FORD AOD NEW 6 CLUTCH DIRECT CLUTCH DRUM

Figure 1

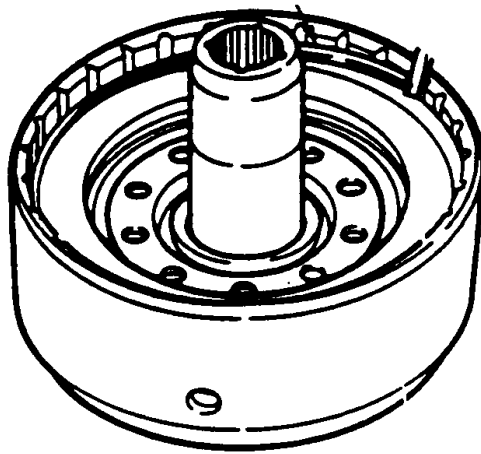
There is now available from OEM a new Direct Clutch Housing that has the capacity increased to 6 lined clutch plates. The new Direct Clutch Housing is the cast iron design (Not Stamped Steel) and still uses the previous piston, return spring, steel plates, pressure plate, and snap ring. Simply add one more lined plate and one more steel plate. The new "6 Pack" Direct Clutch Housing will greatly improve direct clutch durability, and is available under OEM part NO. E8LY-7F283-A.

NEW DESIGN "6 PACK" DIRECT CLUTCH DRUM
